UNITED STATES PATENT AND TRADEMARK OFFICE

APPLICATION NO.	FILING DATE	FIRST NAMED INVENTOR	ATTORNEY DOCKET NO.	CONFIRMATION NO.
09/750,474	12/28/2000	William J. Harrison	ACS-55966 (26991)	6584

Office Action Summary

FIG. 4 (6,042,597)

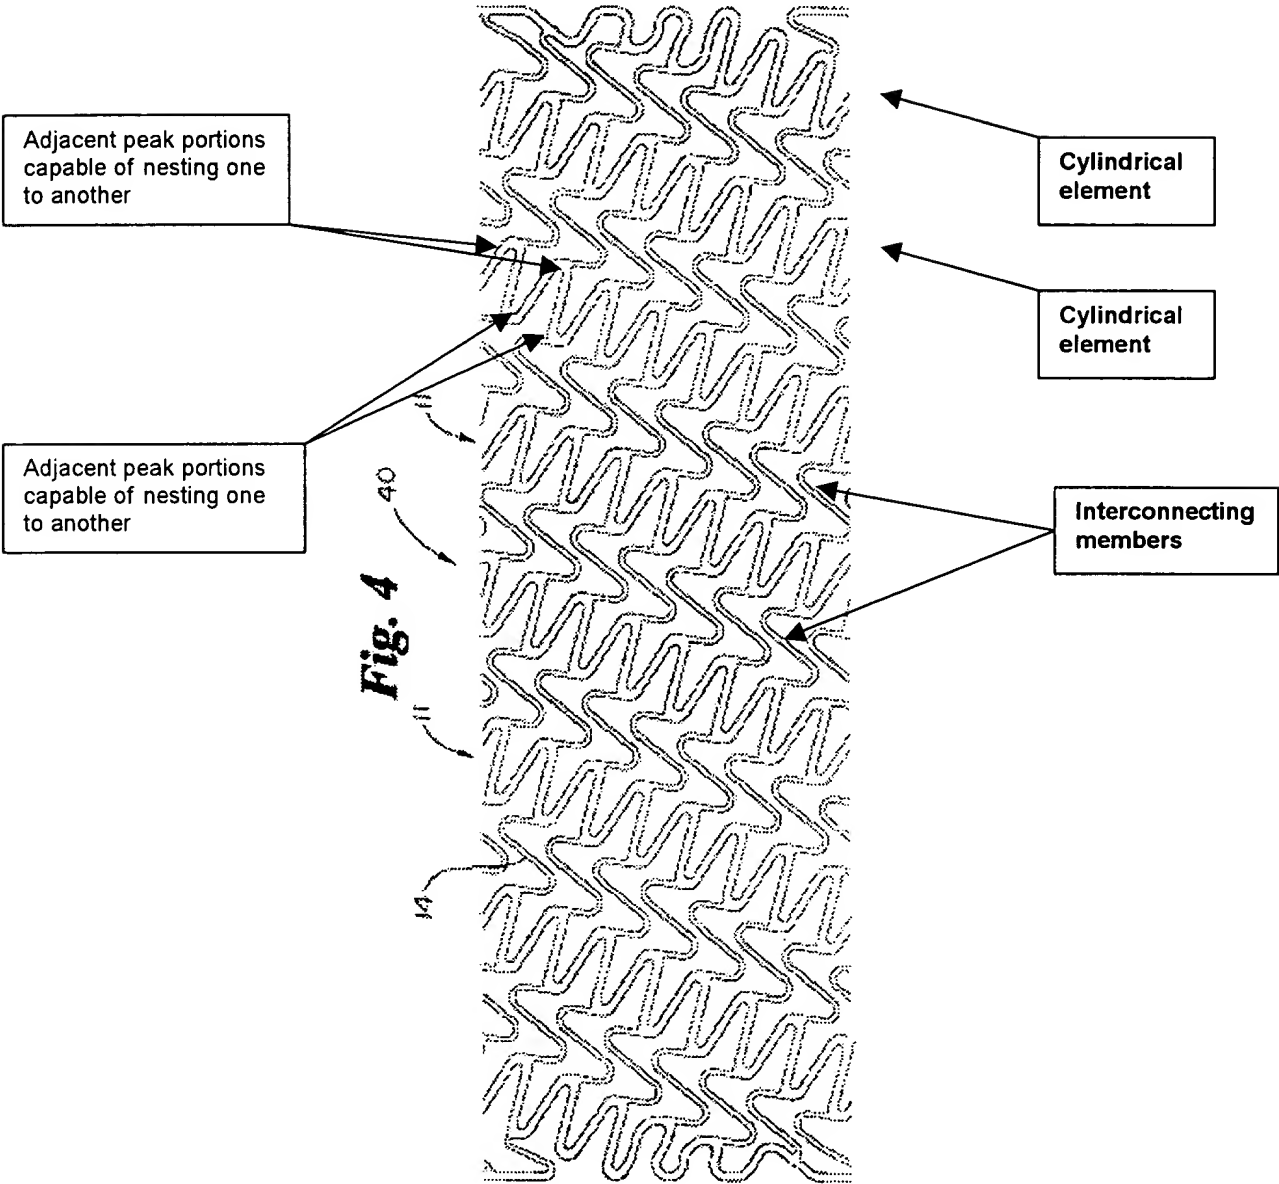
As to claims 1, 21 and 23, KWEEN (Fig. 4 as shown on page 2, this office action) discloses a stent 40 preferably expanded by balloon (column 3, lines 29-36) having substantially cylindrical elements 11, interconnecting members/means for connecting adjacent cylindrical elements together 14, at least two adjacent valley and adjacent peak portions on each cylindrical element 11 are capable of nesting when the stent is crimped or collapsed.

As to claims 2, 5 and 8, KWEEN discloses substantially all structural limitations as recited in the claim, except for each cylindrical element of the stent has at least two valley portions or two peak portions with different longitudinal lengths. It would have been an obvious matter of design choice to make at least two valley portions or peak portions having differing lengths, since such a modification would have involved a mere change in the size of a component. A change in size is generally recognized as being within the level of ordinary skill in the art. In re Rose, 105 USPQ 237 (CCPA 1955).

As to claim 22, KWEEN discloses substantially all structural limitations as recited in the claim. KWEEN does not explicitly disclose the stent is self-expanded. As stated, KWEEN, column 1, lines 38-45), it is well known to make self-expandable stent from a shape-memory alloy, such as Nitinol for easy stent deployment inside a blood vessel. It would have been obvious to one of ordinary skill in the art at the time the invention was made to make KWEEN stent of Nitinol, for example, to make KWEEN stent a self-expandable stent so as to facilitate the stent deployment inside a blood vessel.
